MEMORANDUM

SUBJECT: 2 DUKE STREET (ROBINSON TERMINAL SOUTH)
SITE ELEMENTS AND HISTORIC INTERPRETATION WORK SESSION
BAR CASE # 2015-0205

HISTORIC INTERPRETATION AND SITE FINISHES

Figure 1. Historic shorelines as depicted in OLIN's June 2014 presentation to City Council.

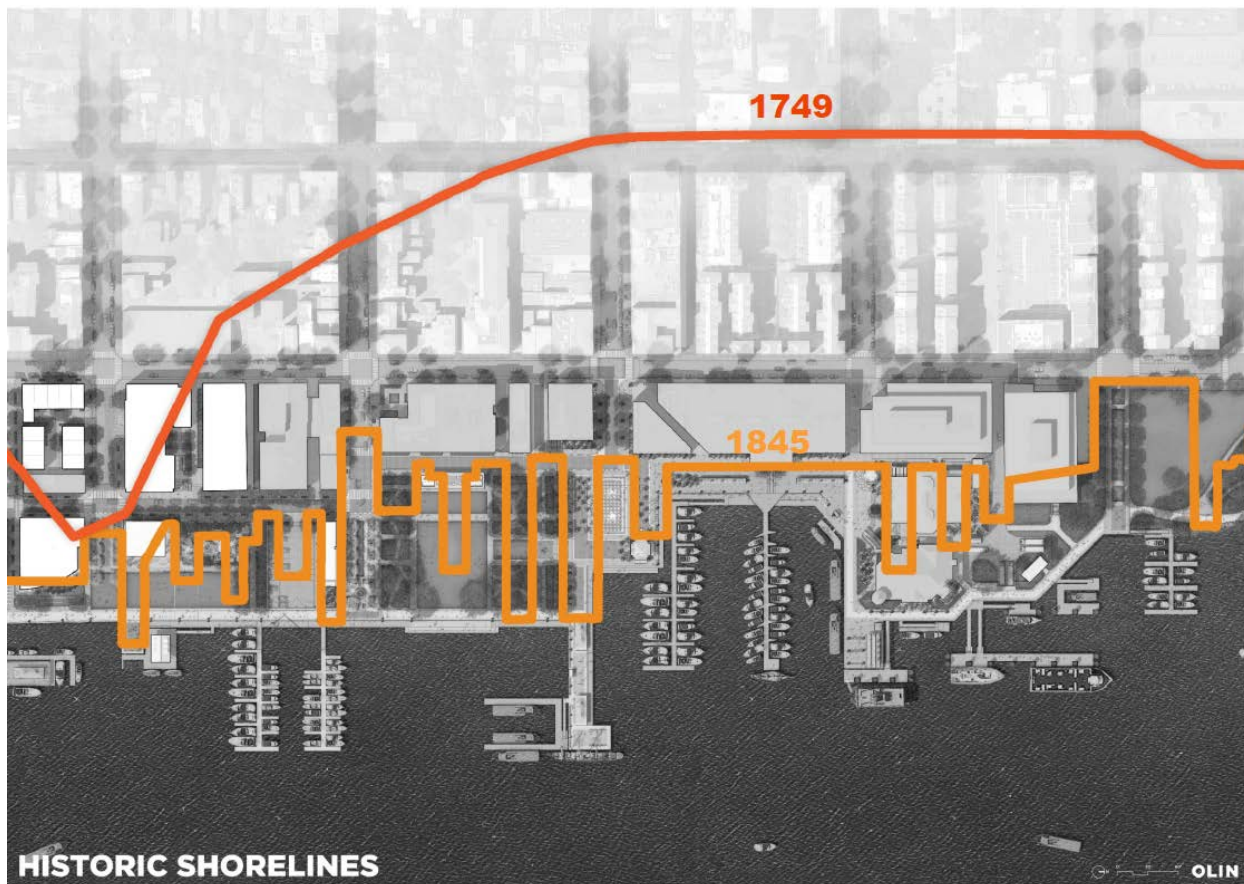
The applicant's proposal at the RTS site is to interpret both of these shorelines, as well as the 1877 pier line because that provides greater insight into the evolution of this particular block which had such a strong industrial history. While it might be too busy to interpret the 1877 pier line across the entire Waterfront Plan area, on the RTS site it provides a great snapshot into the complexity of the ever-changing edge of land and water as many different industries operated on this site over time. Therefore, staff supports the choice to add a third interpretive line here. It should be noted that the 1749 and 1845 delineation must be done in conformance with the overall depiction of these two elements across the plan area, utilizing a common material and vocabulary. The City is currently refining the material selection to delineate the different periods and the applicant will work with city staff and OLIN through this process.

Figure 2. 1912 Building permit for RTS showing location of pair of railroad tracks on Union Street. Source: Alexandria Special Collections

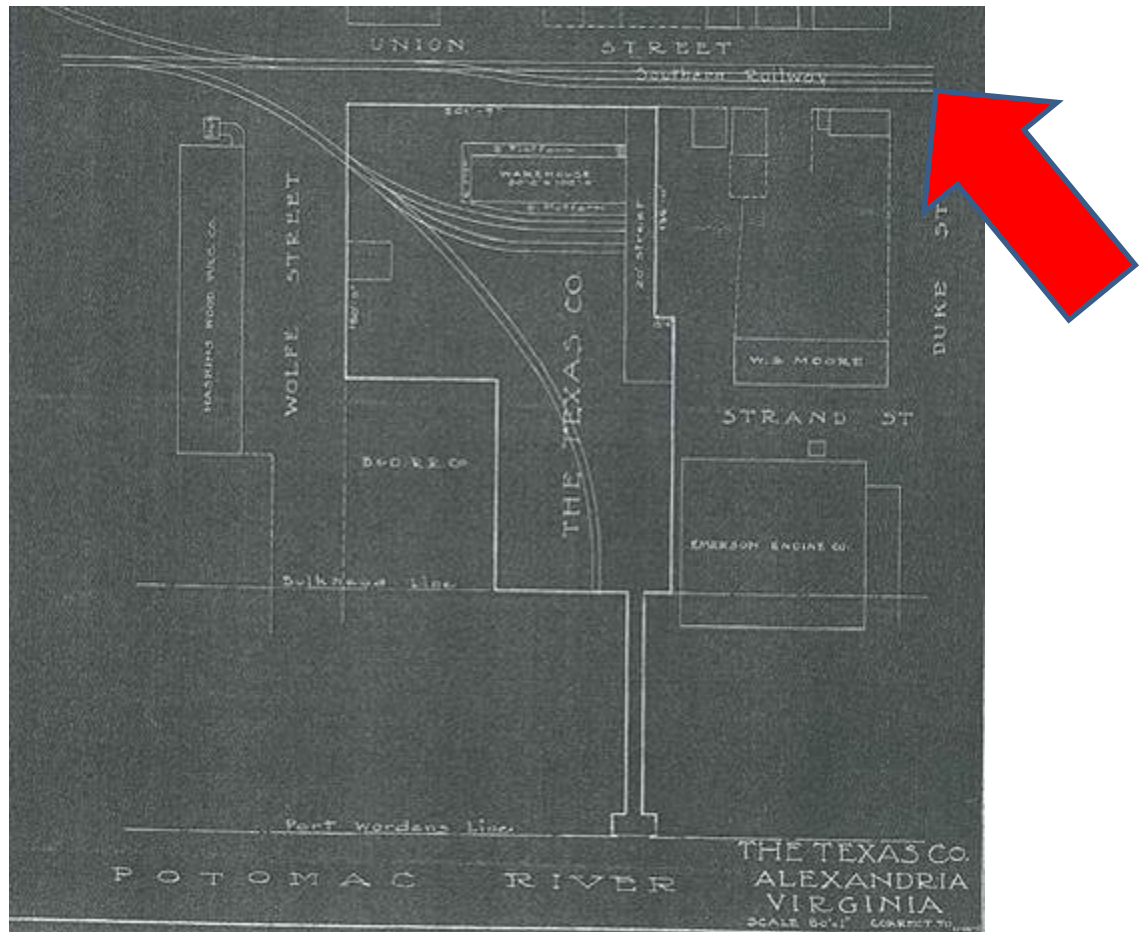
On the western edge of the project site—the east side of South Union Street—the applicant proposes to interpret the railroad tracks through the sidewalk paving materials. While the

original rail line travelled down the middle of Union Street, by 1896 the Southern Railway constructed a second rail line to the east of the center rail line. The applicant proposes to interpret this second rail line in the approximately original location along the sidewalk at the western edge of the project site, with the anticipation that it might relate to a larger rail interpretation extending from the Wilke Street Tunnel. Staff finds that this element is an intriguing one that will be most successful if it can be incorporated beyond this site. This element also provides an interesting connection between the transport of goods from the waterfront over land.
